## Portishead Branch Line (MetroWest Phase 1)

**6.25, Environmental Statement, Volume 4, Appendix 17.1, Flood Risk Assessment, Part 17 of 17**

**6.25, Environmental Statement, Volume 4, Appendix 17.1, Flood Risk Assessment,  
Appendix P Environment Agency consultation response**

## MetroWest Phase 1, Flood Risk Assessment: Consultation meeting with EA

**TITLE**  
UTILITIES INFORMATION  
DROVE RHYNE  
SHEET 1 of 1

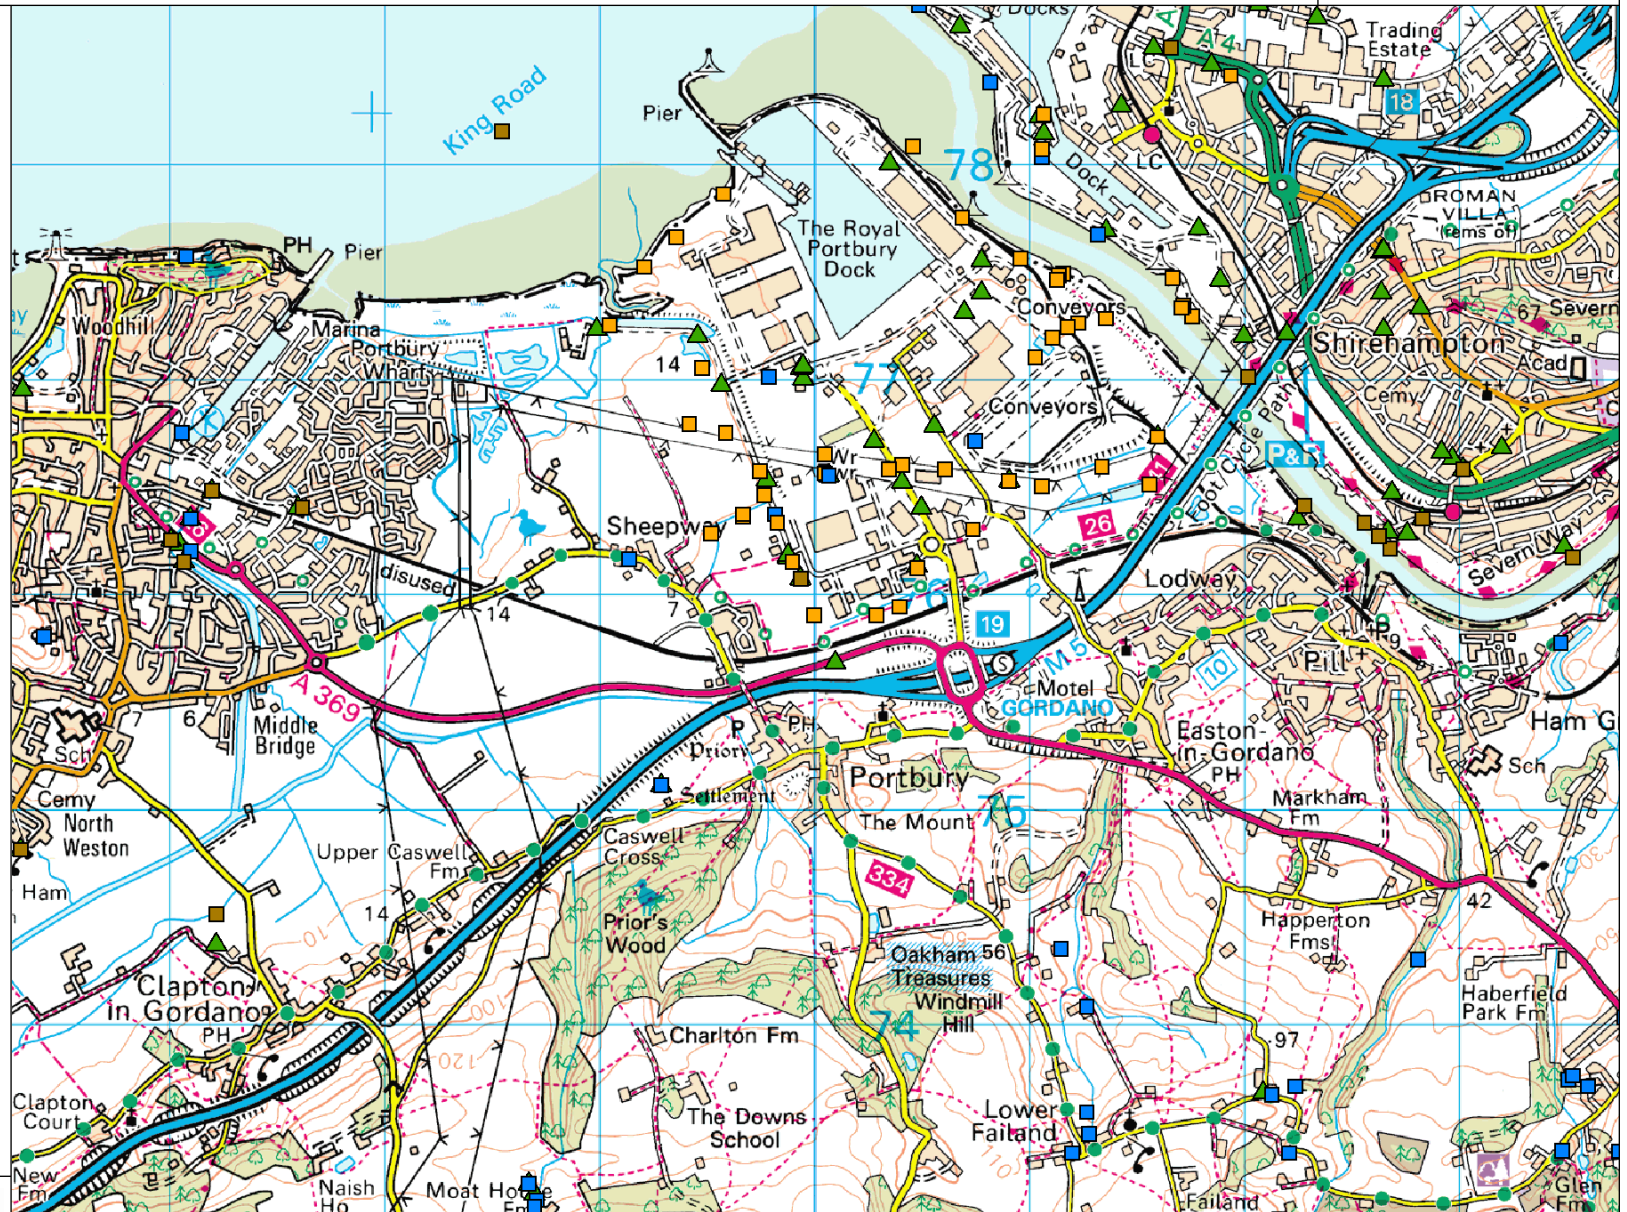
Please find attached a plan that shows our current access route along the Drove Rhyne for weed cutting along the left bank. Our future access to the inland bund via the B3124 is to the left of Sheepway Gate Farm.

# Portishead to Pill DCO Scheme. Discharge Consent Outlets 2 of 5

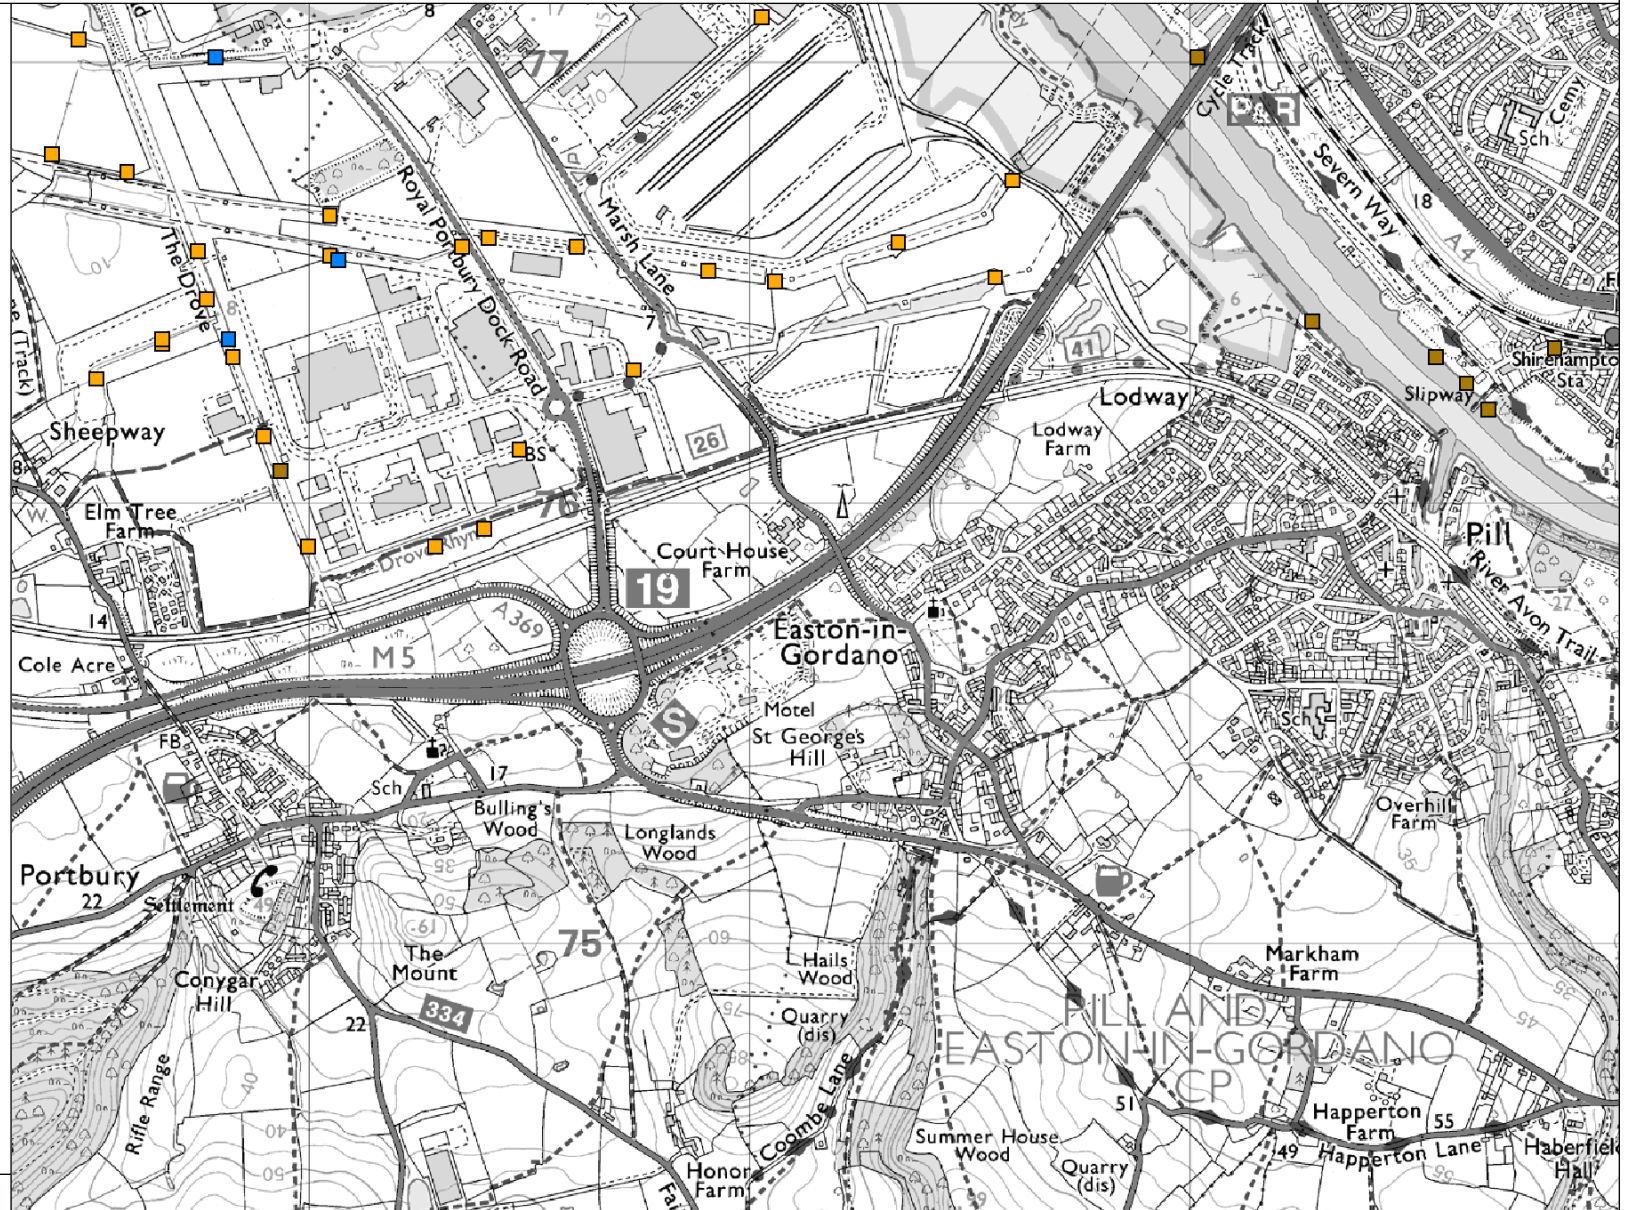
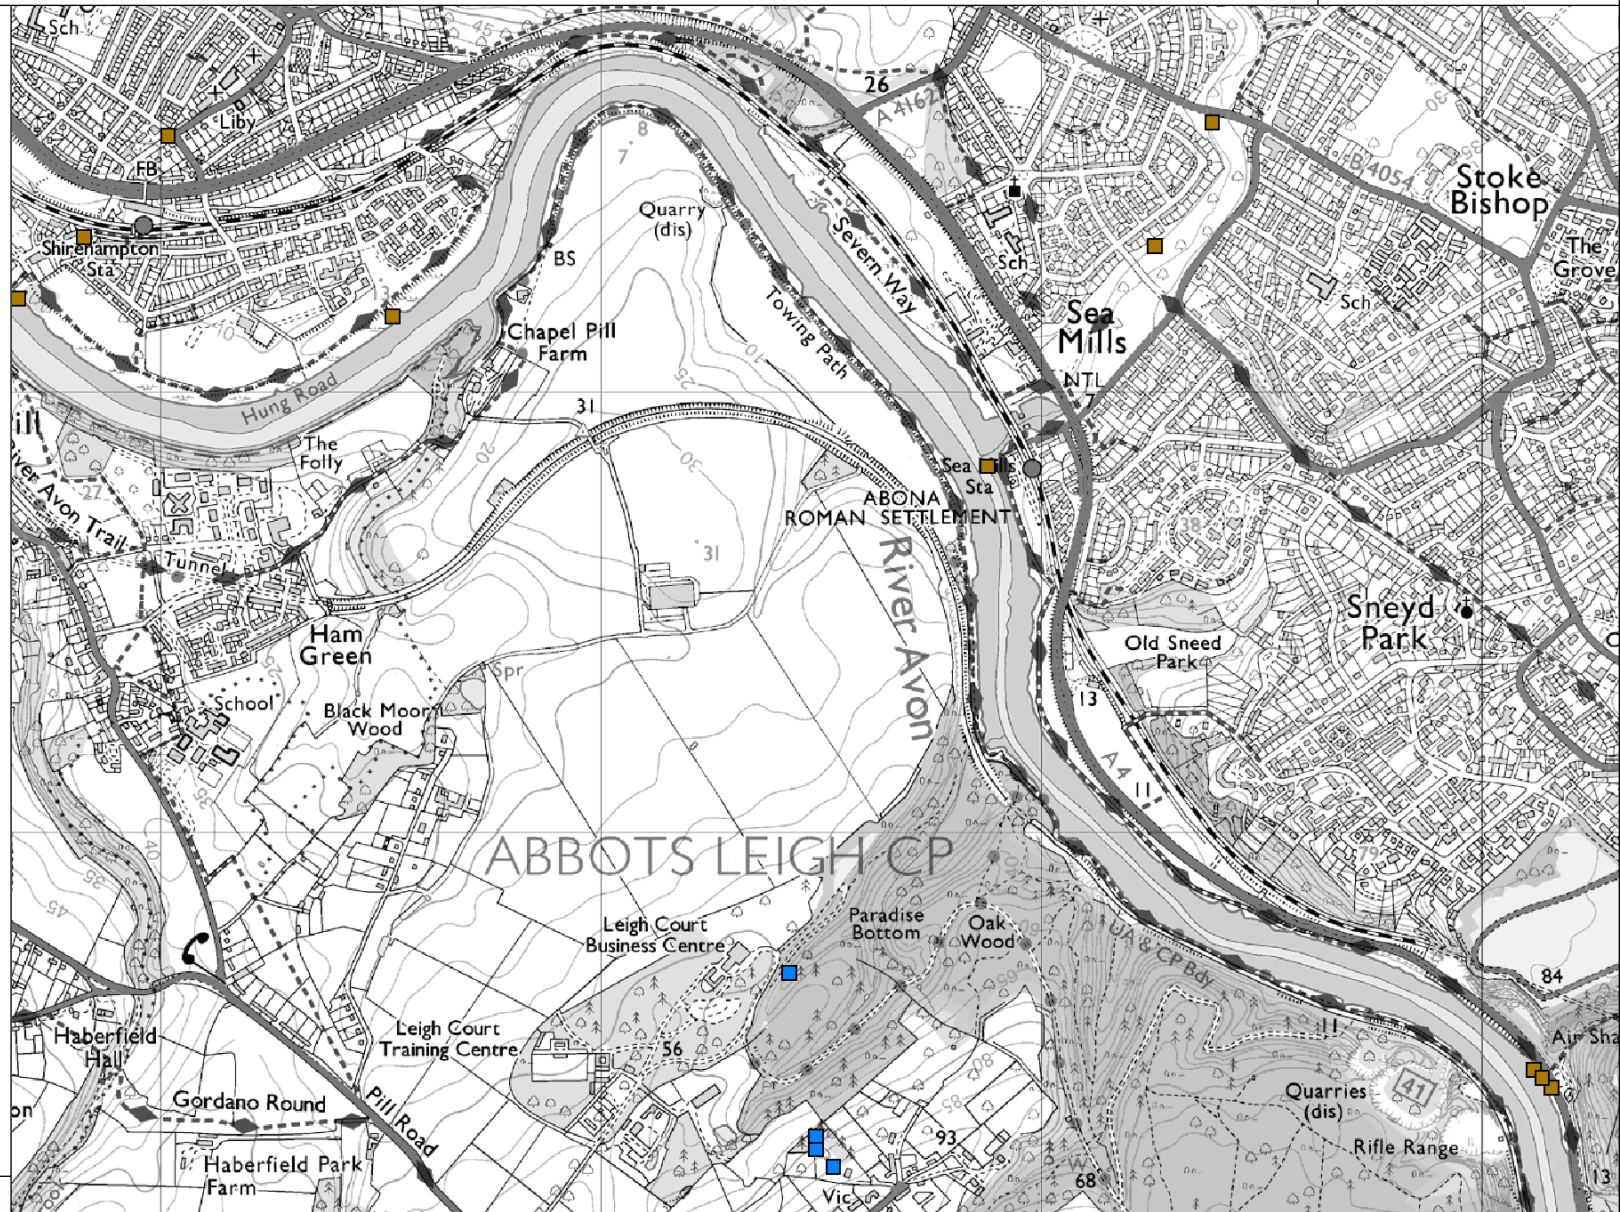
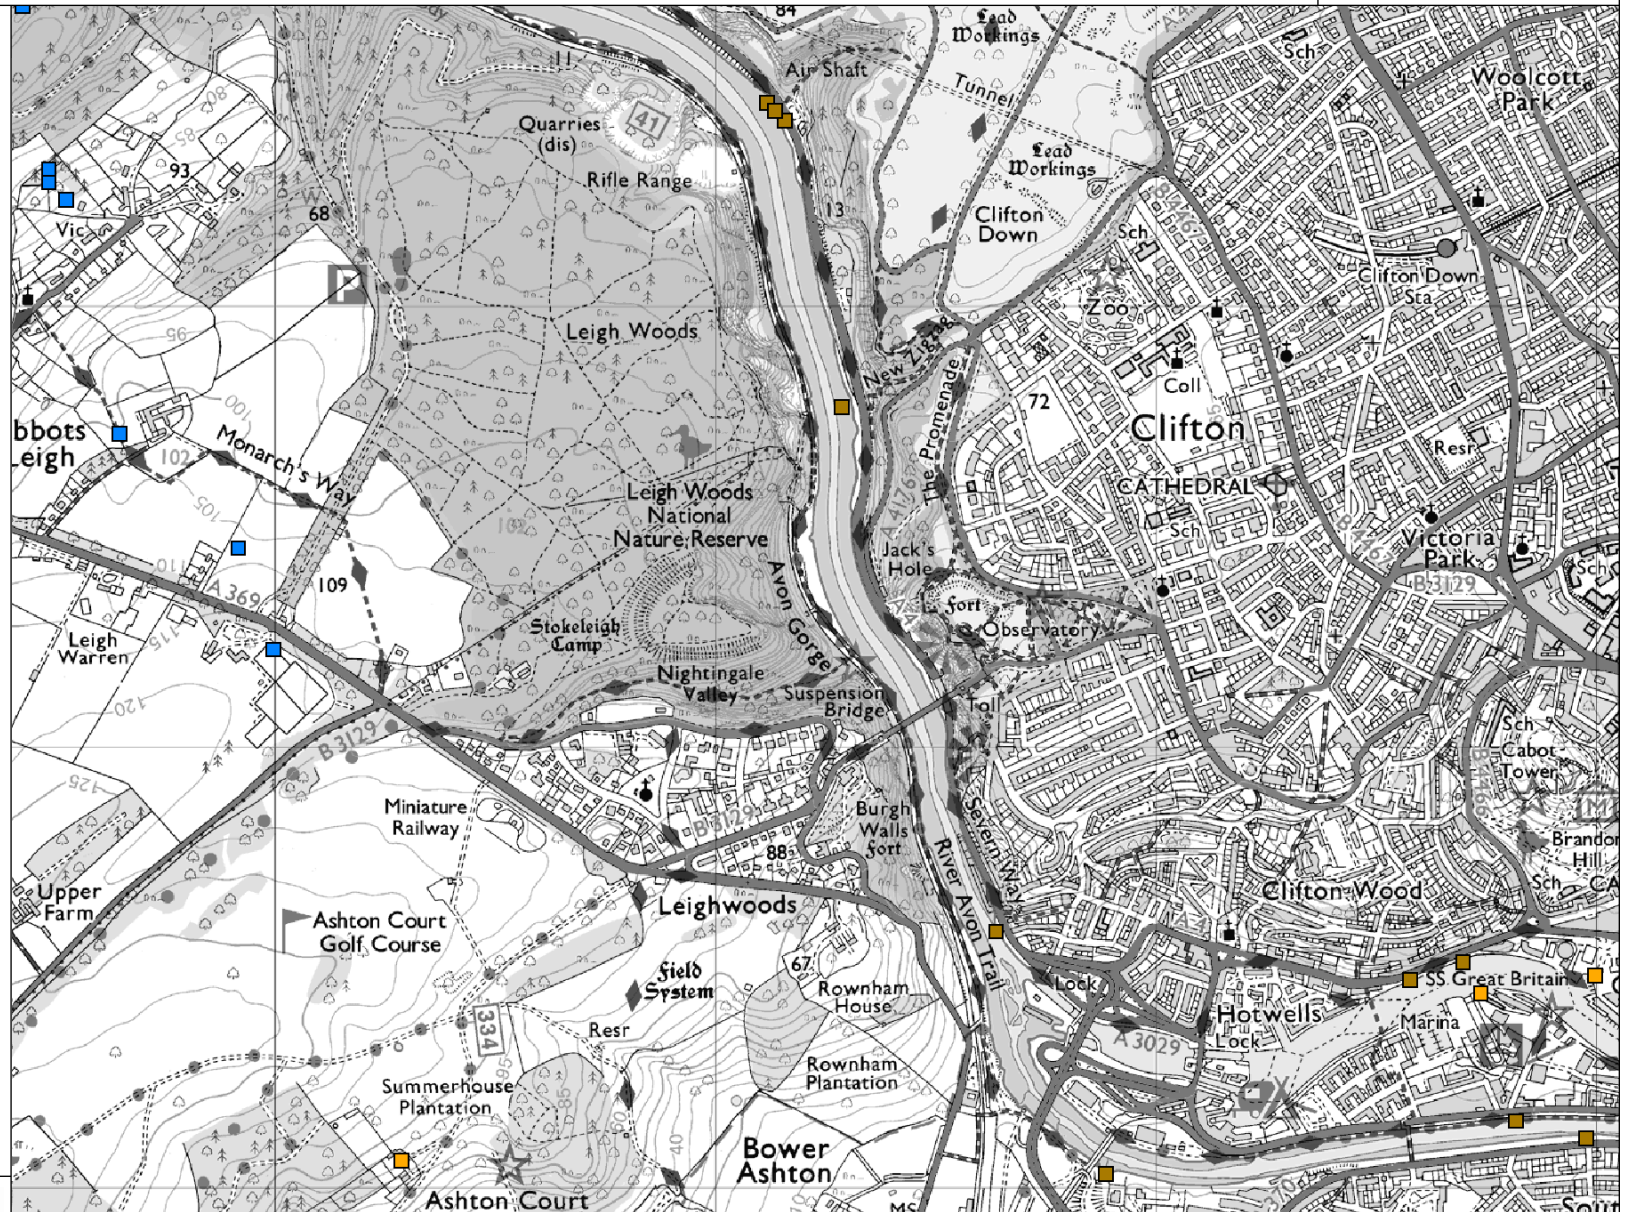
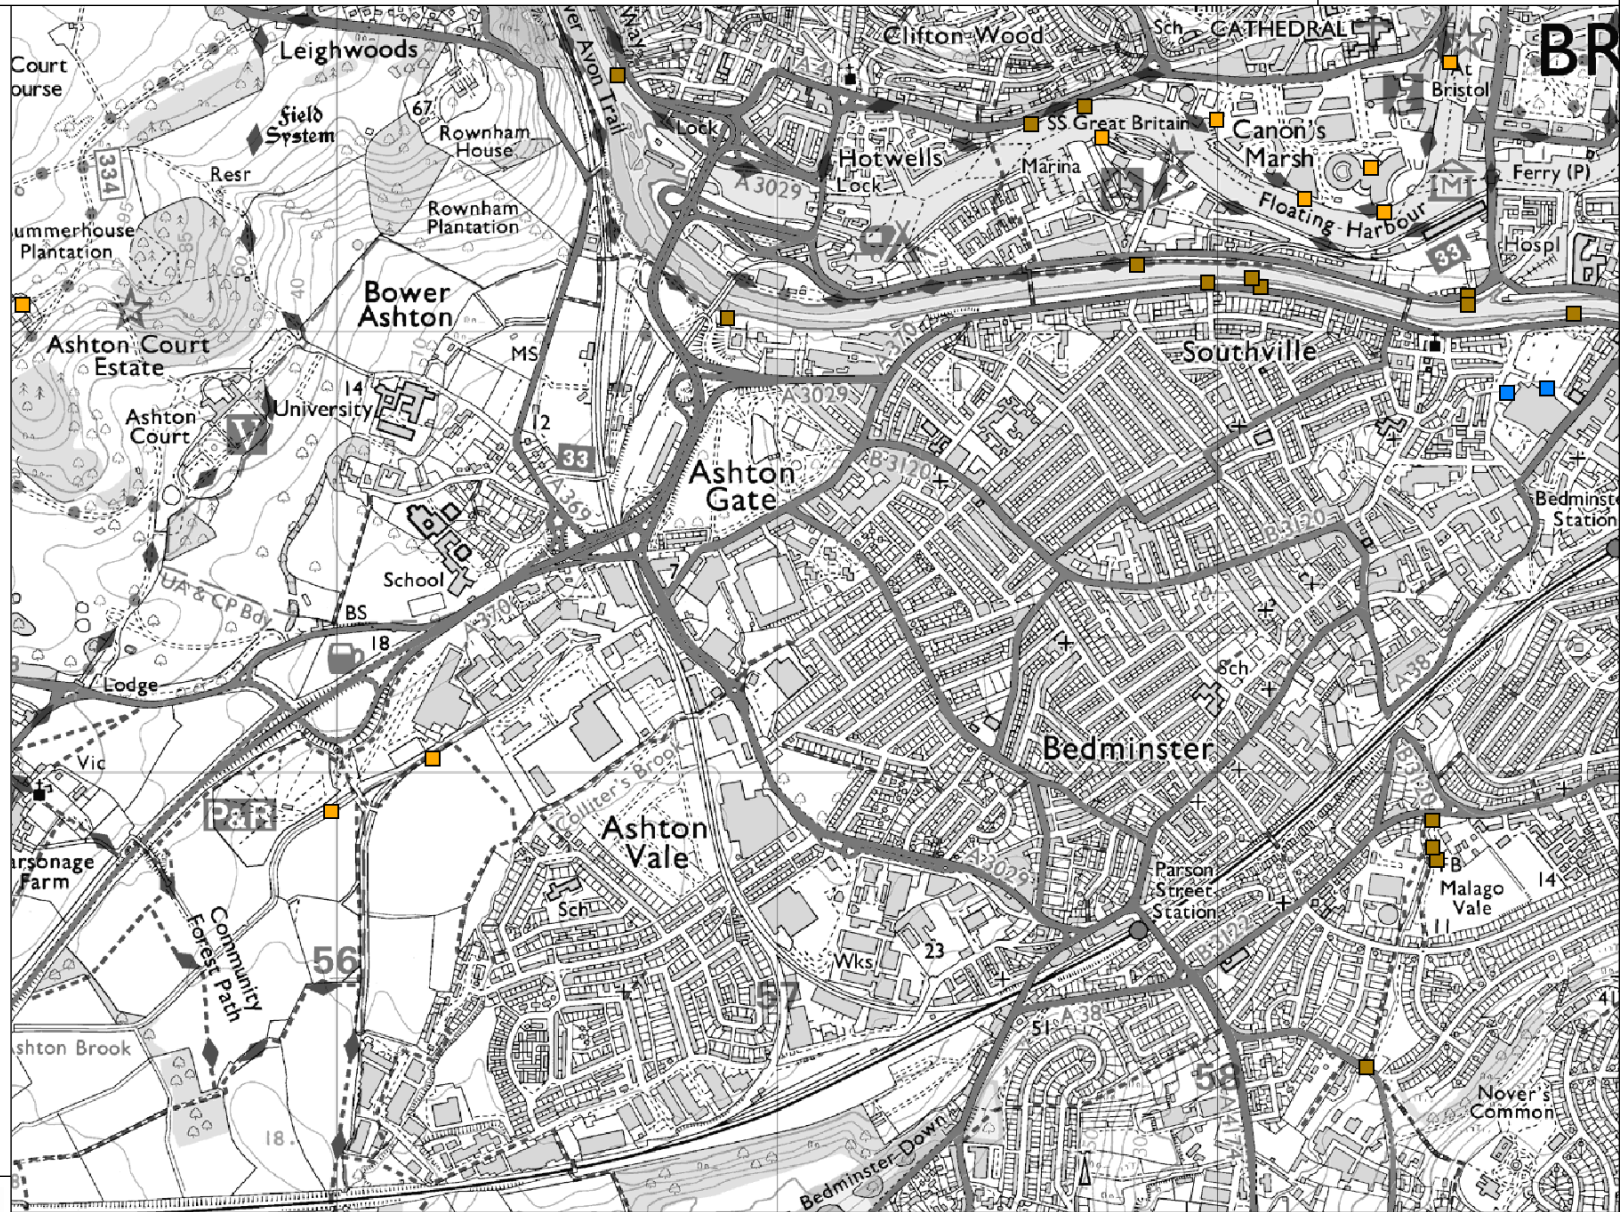
As requested, please find attached a plan indicating the position of all known discharge consents and their associated outlets in the area.
